Access Compliance Report

Public Rights-of-Way

| Intersection ID: N/A | Main Street: INVERNESS_BAY_RD | Cross Street: DALLAS_BAY_RD | Location: NE |
| ADA ID: A8558A615376 | Ramp Type: Perp | Initial Pass/Fail: Fail | Overall Compliance: No |

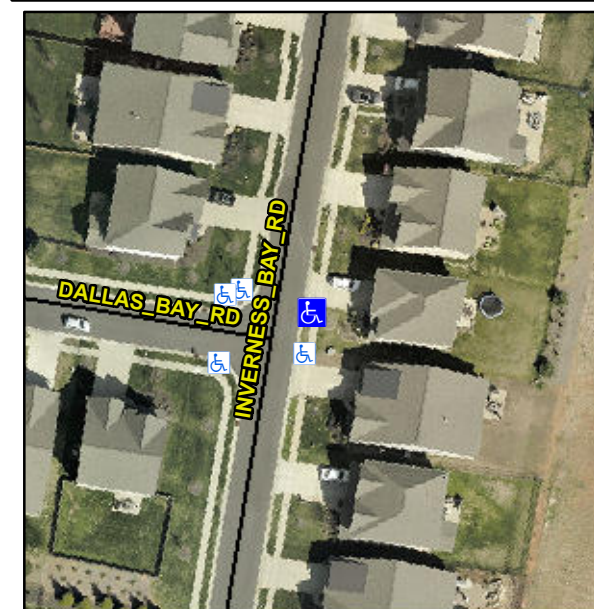
R304.2.2

| Compliance | Description | Data | Compliance | Description | Data |
|------------|-----------------------|-------|------------|-----------------------------|------|
| N/A | Ramp Length (in) | 48.0 | No | Ramp Slope (%) | 11.6 |

Remove & Replace Entire Ramp.
